ADDENDUM NO. 4

Perry Meridian High School Phase 1 – Student Activity Center
401 W. Meridian School Road
Indianapolis, IN 46217

PROJECT: PERRY MERIDIAN HS PHASE 1
PROJECT NUMBER: 24173P
DATE OF ADDENDUM: April 16, 2026

RE: Addendum 04

C-8.13

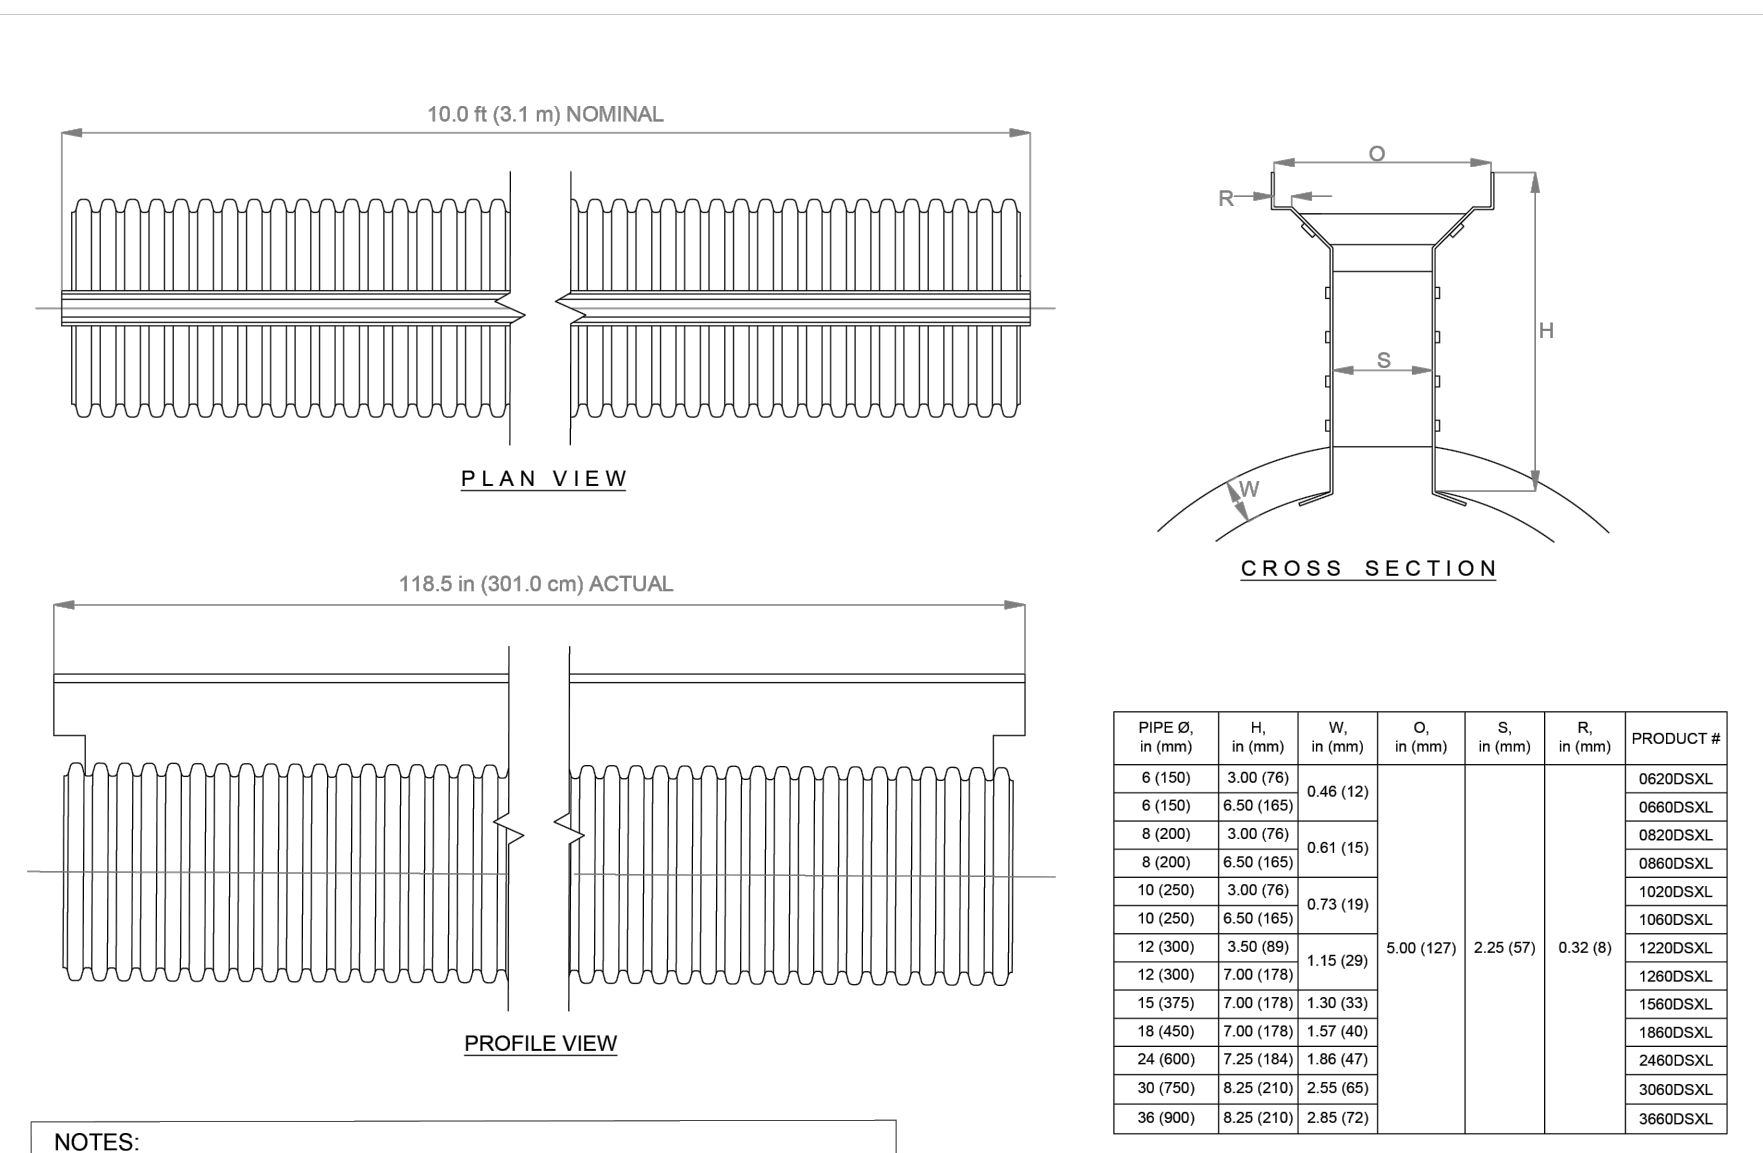
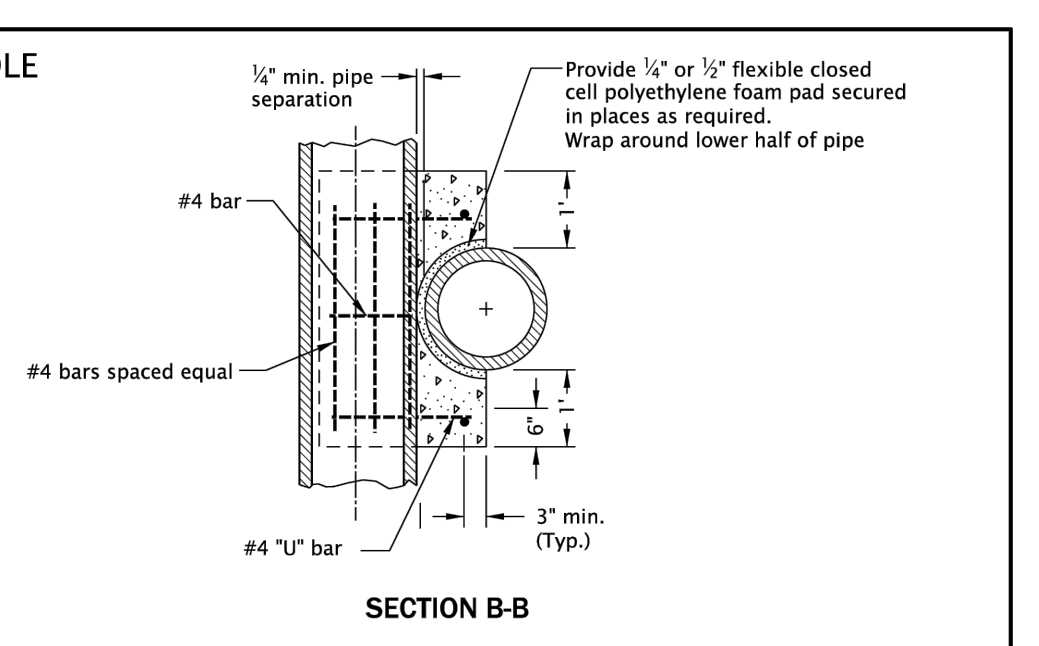
9. **Q:** Retaining Wall/Storm Conflicts – Looks like the 2 storm runs crossing the retaining wall are going to be in the footer. The top of pipe for the 21" RCP will be at an elevation of almost 728 where it crosses the wall, which is only a couple inches lower than the finish grade the face of the wall.
A: See attached JQOL Addendum 04.

Sheet C-8.13

- Reinforced Concrete Saddle detail is included to show what the pipes should be encased in as they are going through the retaining wall.

C-9.4

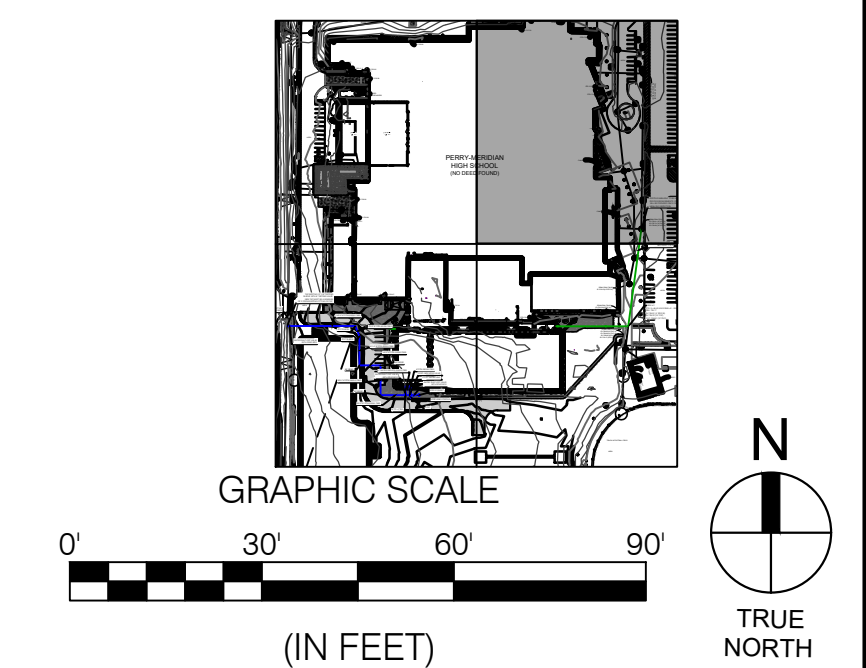
Sheet C-9.4

- Sanitary layout changed based on comments from CEG.
